DRESDEN NUCLEAR POWER STATION, UNIT NO.3

AMENDMENT TO FACILITY OPERATING LICENSE

Amendment No. 76  
License No. DPR-25

ATTACHMENT TO LICENSE AMENDMENT NO. 76

Figure 3.5-1  
(Sheet 2 of 5)

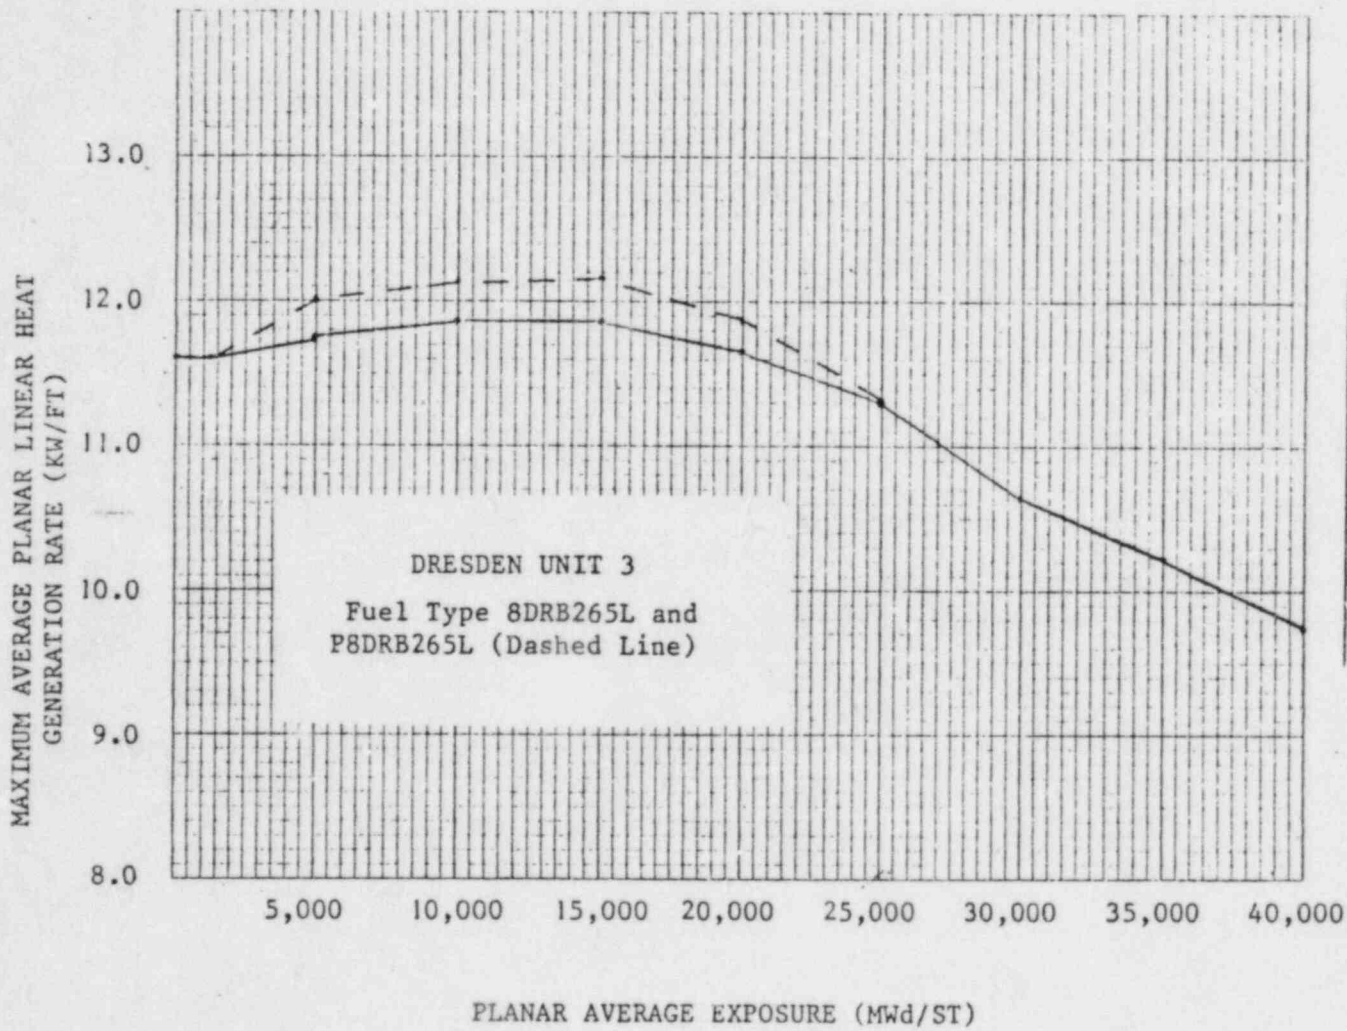
Revise the Technical Specifications by replacing page 3/4.5-18 with a revised page 3/4.5-18.
